2021 INTERIM INSPECTION MEMO Permit No. 17607 Dam ID No. IL 00545

SPRING LAKE DAM
WINNEBAGO, COUNTY, ILLINOIS

October 20, 2021, Field Visit
November 9, 2021, Memo

A lake photo showing lot numbers and required maintenance items is included as an 11 x 17 exhibit.

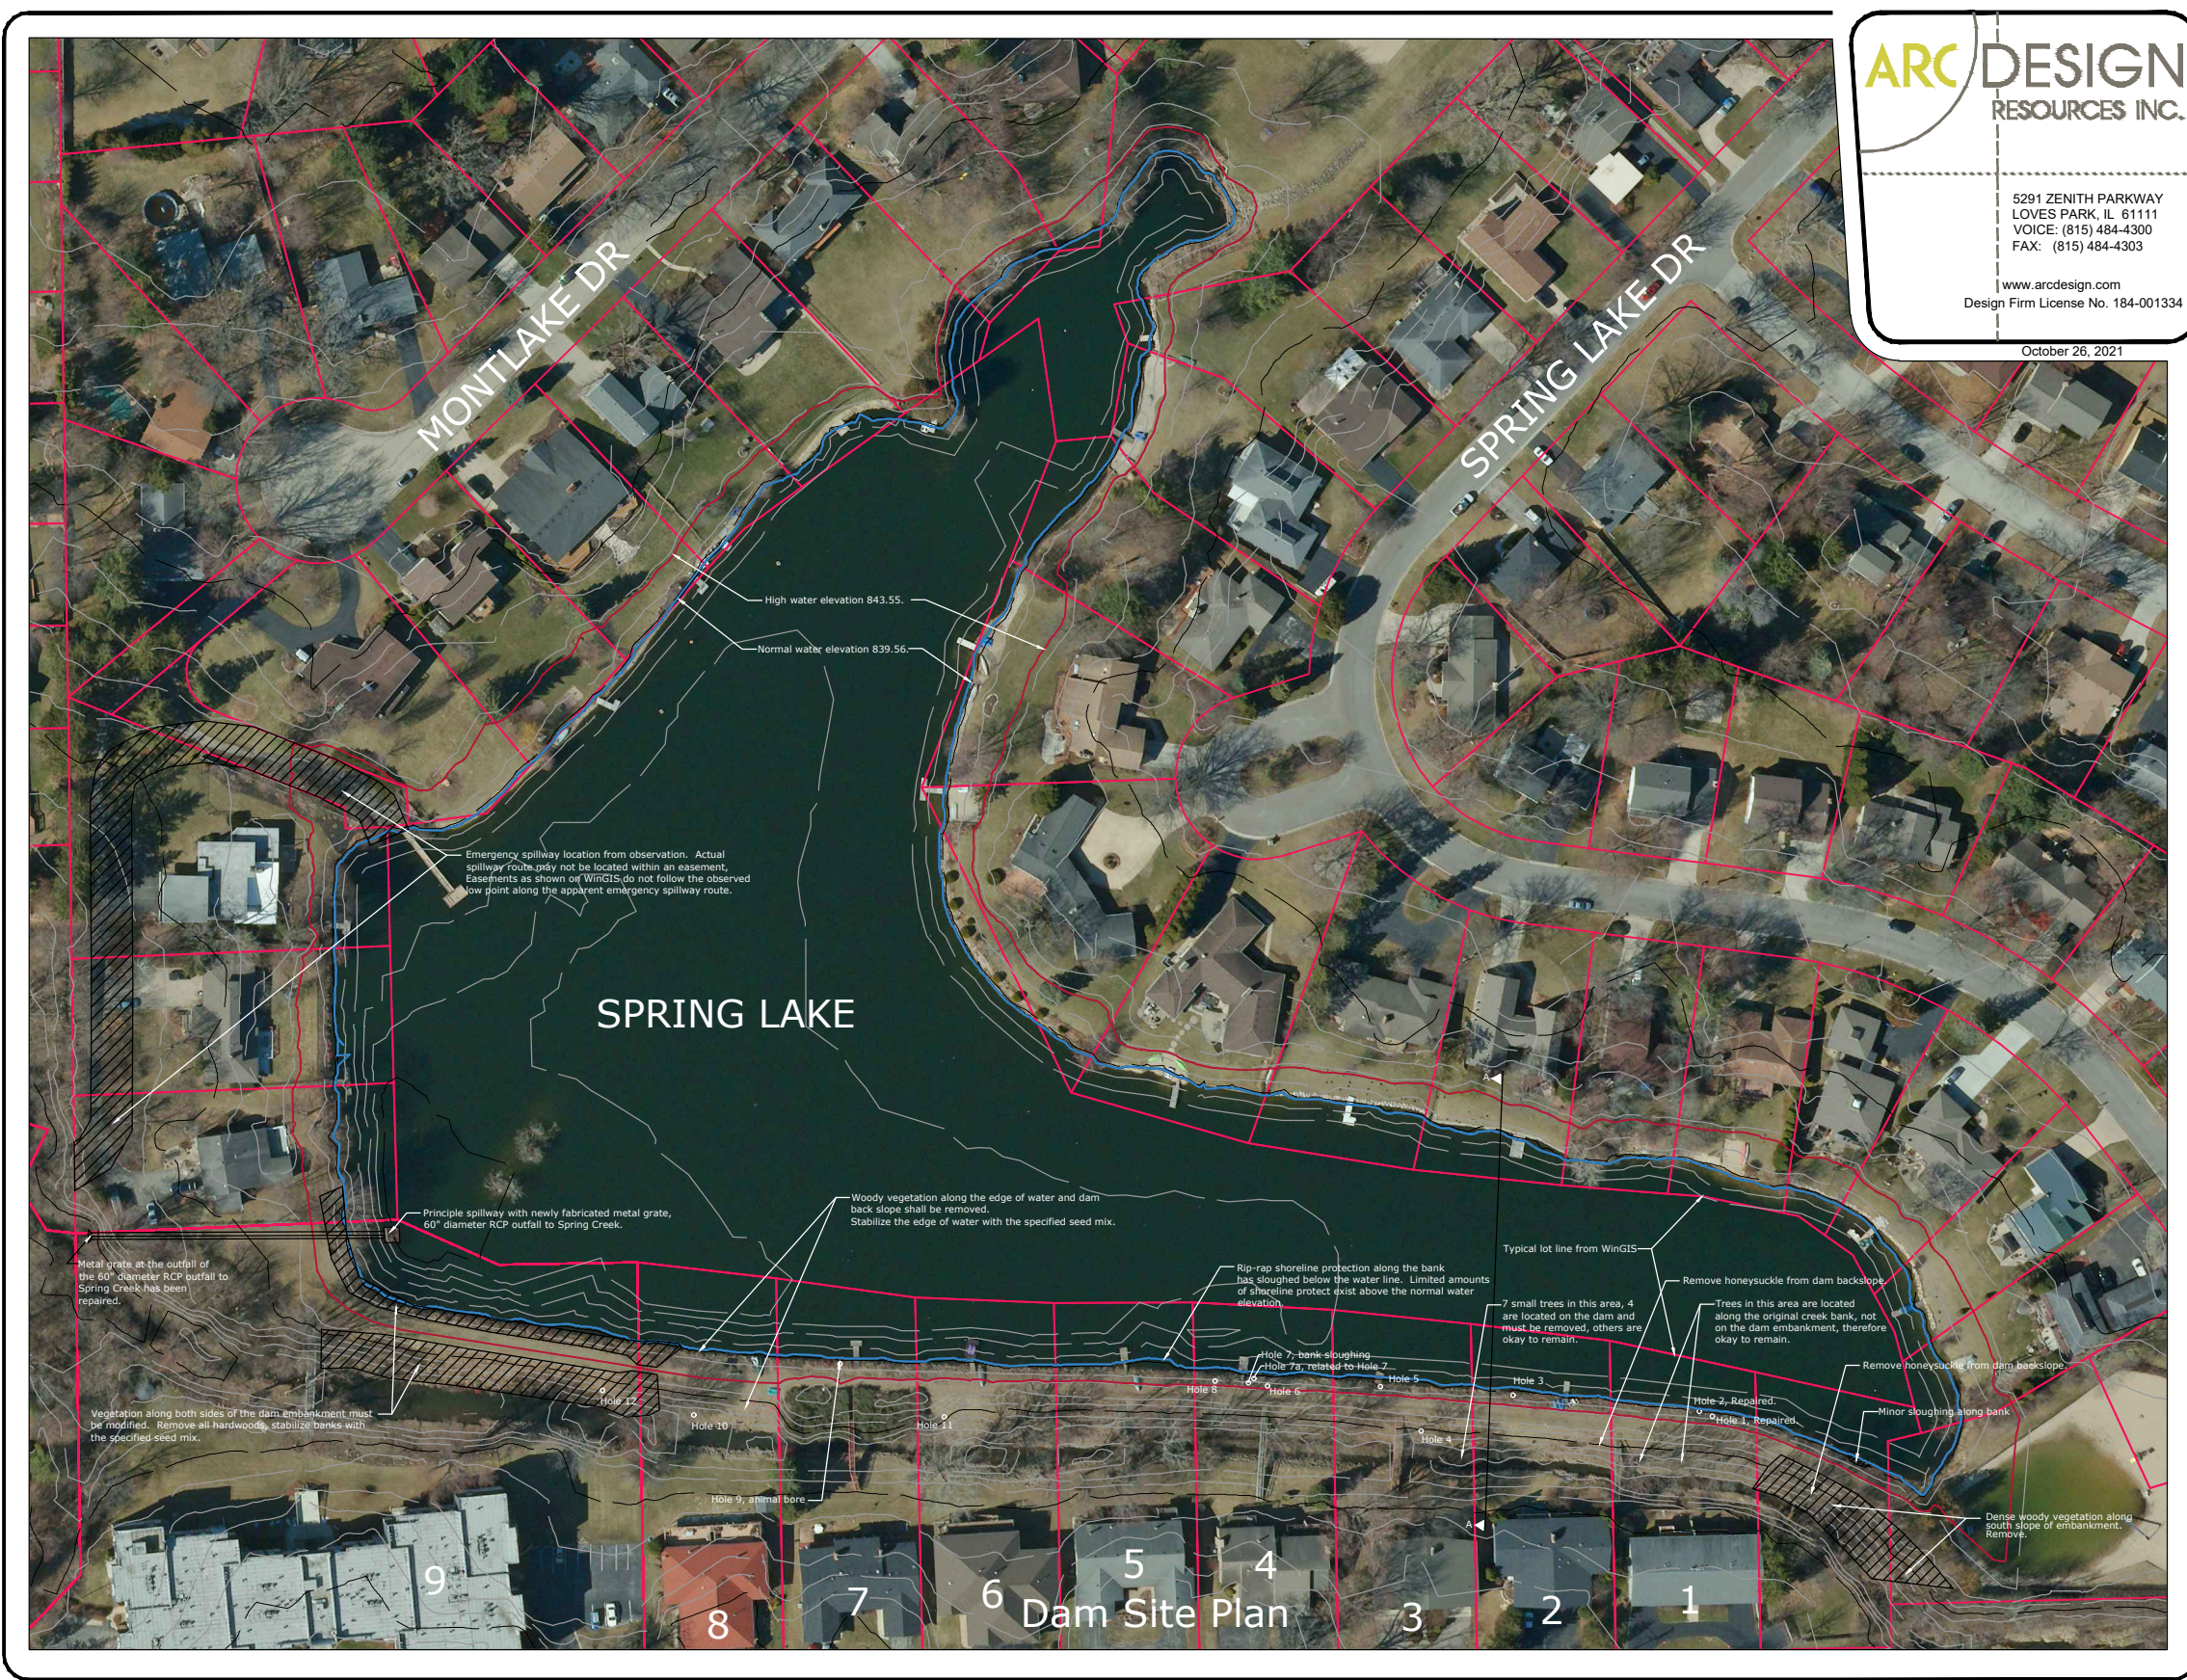
Some repairs on Lot 1 have been completed. Most other lots showed little to no improvements on the recommendations made last October. Embankment deficiencies such as holes and soil sloughs have not been repaired.

Each location needing maintenance was marked in the field with a flagged lath. The specific item needing attention was marked on the lath. Woody vegetation along the water line that must be removed was flagged.

The dam backslope is littered with large pieces of rip rap which makes mowing of the dam backslope very difficult. These large pieces of rock should be moved to the stream bank and off the dam backslope so the future condition of the backslope is mowable.

Previous tree removal on lot 7 should be finalized by stump removal and slope correction.

Item Description on Dam Site Plan	Lot No.	Detailed Description		Repair Recommendation		
Minor sloughing along bank, woody plant material is growing	1	Soil embankment slope has become steeper due to lack of stabilizing rip-rap. Woody plant material along bank.		When lake level is down 2 feet, recompact weakened soil plane, add compacted clay, line with geotextile fabric, pull up sloughed rip rap along repaired slope to two feet above normal water level. Remove plants from edge of water.		
Hole 1	1	6" diameter hole in surface of dam face		Repairs have been completed.		
Hole 2	1	6" diameter hole in surface of dam face at water level		Repairs have been completed.		
Hole 3	2	3-4" diameter hole in surface of dam face		Remove vegetation, fill with compacted clay, cap with 4" of topsoil, seed with specified seed mix.		
7 small trees in this area, four on the back slope of the dam must be removed	2-3	3 of the 7 trees in this area must be removed because they are on the back slope of the dam. The remaining trees are in the creek channel.		Remove tree, cut stump off level with ground surface, treat stump with herbicide. Remove vegetation along the edge of water. Remove honeysuckle from backslope.

Hole 4	3	3-4" diameter hole in surface of dam face, back slope		Hole has been filled, the back slope of the dam has been disturbed and must be regraded to and compacted to original grades. Remove vegetation along the edge of water.		
Hole 5	3	3-4" diameter hole in surface of dam face		Remove vegetation, fill with compacted clay, cap with 4" of topsoil, seed with specified seed mix. Remove vegetation along the edge of water.		
Hole 6	4	4' diameter hole in surface of dam face		Remove vegetation, fill with compacted clay, cap with 4" of topsoil, seed with specified seed mix. Remove vegetation along the edge of water.		
Hole 7	4	4' x 3' slough in surface of dam face upslope from rip-rap		Remove dislodged soil and vegetation, fill with compacted clay, cap with 4" of topsoil, seed with specified seed mix. Remove vegetation along the edge of water.		
Hole 7a - related to adjacent slough	4	2' x 2' slough in surface of dam face upslope from rip-rap		Remove dislodged soil and vegetation, fill with compacted clay, cap with 4" of topsoil, seed with specified seed mix. Remove vegetation along the edge of water.

Hole 8	4	minor slough in surface of dam face, backslope surface repairs.		Removed dislodged soil, remove vegetation, fill with compacted clay, cap with 4" of topsoil, seed with specified seed mix. Remove vegetation along the edge of water. Repair backslope at toe of dam.		
Remove two trees from the backslope of the dam embankment, trees are flagged.	4	Remove trees		Grind stumps, fill with compacted clay, cap with 4" of topsoil, seed with specified seed mix.		
Woody vegetation along water's edge	5-6	Remove woody stemmed plants		Grind stumps, fill with compacted clay, cap with 4" of topsoil, seed with specified seed mix.		
Hole 11 - dam back slope also has grading irregularities in this area.	6	An animal bore hole exists, the area surrounding the hole is poorly graded.		Fill hole with compacted clay, regrade the area to match the adjacent grades, compact and restore the surface with the specified seed mix.

Vegetation along the back slope of the embankment must be removed	7	Evergreen plants have been removed		Replace disturbed soil with compacted clay, cover with 4" of topsoil, apply specified seed mix.		
Hole 9, animal bore	7	2" diameter hole in surface of dam face		Remove vegetation, fill with compacted clay, cap with 4" of topsoil, seed with specified seed mix.		
Hole 10	8	3-4" diameter hole in back slope surface of dam face		Repair has been completed. Remove woody plants from the edge of water.		
Large maple tree, honey suckel shrubs	8-9	Trim maple tree to let sun light on dam bank. Remove all honey suckel shrubs.		Trim tree, (trimming complete) remove woody plant material and roots. Replace disturbed soil with compacted clay, cover with 4" of topsoil, apply specified seed mix.		
Vegetation along both sides of the dam embankment must be modified	9	Excessive plant growth on dam embankment and along water's edge is not acceptable.		Remove all woody plant material and roots. Replace disturbed soil with compacted clay, cover with 4" of topsoil, apply specified seed mix.

Hole 12	9	2" diameter hole in in backslope of dam		Fill hole with compacted clay, cover with 4" of topsoil, apply specified seed mix.
